Process Change Notification

PCN Number: PCN-2016-48

STATS ChipPAC* Assembly, Test and Final Pack Site Transfer from Shanghai to Jiangyin CHINA

Below is a 2D representative image of the Package: MF (Mark Format) = 193 Rev A

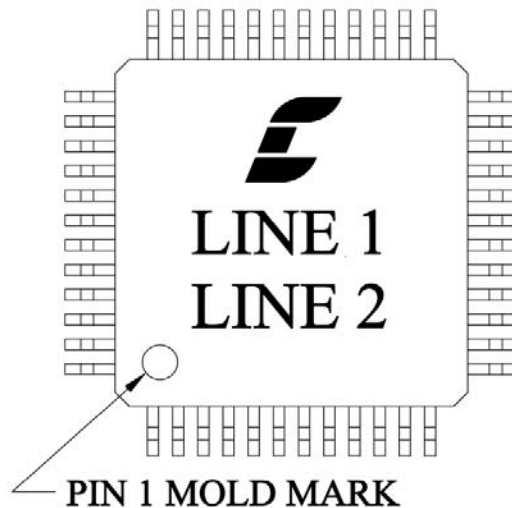
There is "NO CHANGE" to the external face of the designated components.
